Access Compliance Report Public Rights-of-Way (Curb Ramps)

Main Street: UNIVERSITY_DR Cross Street: REDLANDS_DR Location: N

ADA ID: RPRK211018110838 Ramp Type: Type 4 - Parallel Initial Pass/Fail: Fail Overall Compliance: No Severity Score: 2

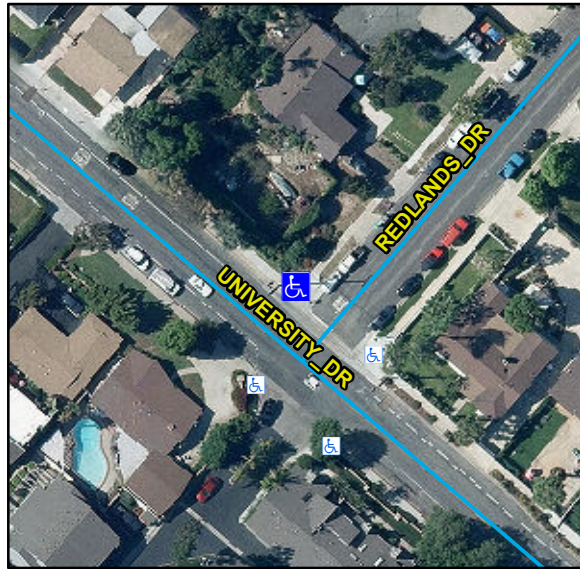
Compliance	Description	Data	Compliance	Description	Data
N/A	Ramp Length LT (in)	93	N/A	Ramp Length RT (in)	100
Yes	Ramp Width LT (in)	100	Yes	Ramp Width RT (in)	103
Yes	Ramp Run Slope LT (%)	0.3	Yes	Ramp Run Slope RT (%)	5.4
No	Ramp Cross Slope LT (%)	3.9	No	Ramp Cross Slope RT (%)	3.9
N/A	Landing Present	N/A	N/A	DWS Provided	N/A
N/A	Landing Length (in)	N/A	N/A	DWS Contrast	N/A
N/A	Landing Width (in)	N/A	N/A	DWS Length (in)	N/A
N/A	Landing Run Slope (%)	N/A	N/A	DWS Full Width	N/A
N/A	Landing Cross Slope (%)	N/A		DWS Offset Type	N/A
N/A	Landing Movement Obstructed?	N/A	N/A	DWS Offset Left (in)	N/A
	Landing Movement Type	N/A	N/A	DWS Offset Right (in)	N/A
N/A	Landing Shared	N/A			
N/A	Clear Space	Yes			
N/A	Clear Space To Crosswalk (in)	N/A			
N/A	Marked Crosswalk 1	No	N/A	Marked Crosswalk 2	No
	Crossing 1 Direction	SW		Crossing 2 Direction	SE
N/A	Marked Crosswalk 1 Width (in)	N/A		Marked Crosswalk 2 Width (in)	N/A

Possible Solutions:

Remove & Replace Curb Ramp With Two New Directional Ramps or Equivalent.

R304.5.3, STD 1115
